Attachment 9 REVIEW 1					
			16-9112	CP&D CITY OF OLYMPIA					
		07/12/2019 1:11:20 PM							
SUBSTANTIVE REVIEW COMMENTS 2/13/2017         NOTE: Application vested to codes prior to code changes adopted after December 1, 2016       kcarlson									
	NOTE: Engineering Option B amendment added 24-Apr-2017								
	· · · · · · · · · · · · · · · · · · ·	1		"					
Note: Please typ		on; doing so may delay	<i>nt Response</i> , and include as much information needed to clearly respond to each comment. Please do not say resubmittal. Additionally, please avoid referring to the plans without a sheet number, or explanation of how

#### 16-9112 HARRISON AVENUE MIXED USE BSP PRELIMINARY BINDING SITE PLAN 2<sup>nd</sup> SUBSTANTIVE REVIEW COMMENTS November 4, 2019 NOTE: Application vested to codes prior to code changes adopted after December 1, 2016 Note: Please type your responses into the column titled Applicant Response, and include as much information needed to clearly respond to each comment. Please do not say "o explanation; doing so may delay resubmittal. Additionally, please avoid referring to the plans without a sheet number, or explanation of how the COMMENT OR REQUESTED ITEM CODE RE

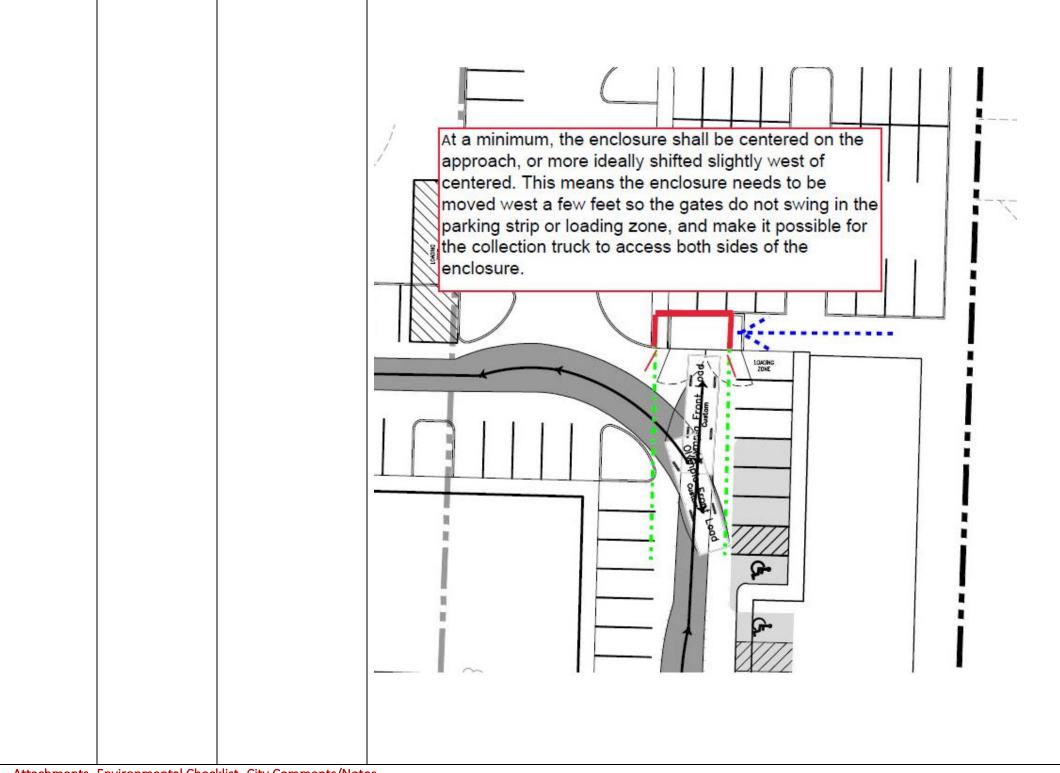
WWHM screen print for Scenario Schematic: None of the elements are labeled, so we are guessing how the following screen prints fit within the diagram.
	WWHM screen print for Permeable Pavement 1.
	o The area of permeable pavement = 46,000 s.f. (1.056 Acres), again does not match any of the areas presented thus
	far. o 12 underdrain?
	WWHM screen print for 3rd Ave Trench Basin: Again, the areas (0.087 ac road, 0.052 ac sidewalk, and 0.051 ac lawn) do not match any of the areas presented thus far.
	WWHM Report - Predeveloped Basin 1 (page 23) has a total basin area of 2.96 acres, which is close to the 2.97 acres shown
	in the Area Summary on page 10. The value of 2.96 acres does appear to equal the sum of Lots 2, 3, 4, and 5, plus 3rd Avenue Extension, and not include Craftsman.
	WWHM Report Permeable Pavement 1 basin definition: The Pavement Area is shown as 1.0560 ft instead of 1.0560 acres.
	WWHM Report: When all of the basin areas are totaled (Permeable Pavement 1 = 1.056 ac, Buildings = 0.790 ac to pavement gallery, Sidewalk to pavement gallery = 0.180 ac., Landscape to pavement gallery = 0.840 ac, 3rd Avenue = 0.190 ac, and Craftsman = 0.163 ac), they equal = 3.219 acres. This does not match any of the numbers presented thus far.

The numbers that do appear consistent are the buildings (0.79 ac) and sidewalk (0.301 ac.), but this took breaking down three basin definitions to determine that these were correct.
	The plat shows two approaches coming off the 3rd Avenue extension. Are these approaches made of concrete, and are they included in the basin area?
	Are the off-site approaches to Harrison Avenue (work within existing City right of way) included in the area calculations? Is this where some of the confusion with areas not matching come from?
	WATER QUALITY STORMFILTERS
	Checking the Water Quality Flow Rates in WWHM appear to be correct, given the project areas used, and given that a
	single Contech StormFilter cartridge can treat up to 0.033 cfs. 3rd Avenue appears to be just under the limit for a single cartridge (at 0.0306 cfs).
	Sta Avenue appears to be just under the innit for a single cartilage (at 0.0500 cis).

Craftsman is just over the limit (at 0.0352 cfs) and should be increased to 2 cartridges.
	THRESHOLD DISCHARGE AREAS (TDAs)
	Lot 5 should be broken into its own TDA, because 3rd Avenue separates the gravel interflow from the rest of the
	development. The pervious pavement for Lot 5 should not be included in the pervious pavement modeling for the rest of the development.
	BINDING SITE PLAN
	Please include an area for the Craftsman Dr NW right of way dedication.
	Please include a floor 1 surface area for the buildings on Lot 5.

Unfortunately, WWHM2012 does not label the elements in the overview window. The screenshots and output file have been grouped together for each Basin in Min Req 7. Permeable pavement has been broken out into two areas as requested below. 12" underdrain is a default in the program. This is not utilized and was removed for clarity. It did not affect facility sizing as there was no discharge from the underdrain. 3<sup>rd</sup> Ave Basin areas updated in min req 7. Refer to Min Req 7 for all basin areas. Unsure of why this error occurs. WWHM2012 was rechecked for area accuracy of the square footage and calculations were re-run (see screen shot before text report). This is also an error in Basin 2. The text output simply placed ft instead of acres. Refer to Min Req. 7 for area break down. These approaches are made of standard concrete and included in Basin 3. See Min Req 7 for basin map No areas in the ROW are included as they are replacing existing concrete driveways that drain to Harrison Ave and do not have a way to be collected independently of the existing system in Harrison Ave correct Water quality sizing has been updated to show 2 filters required. Lot 5 has been broken out (basin 4) from Lot 2/3/4 (basin 2) for the porous pavement modeling. Done.
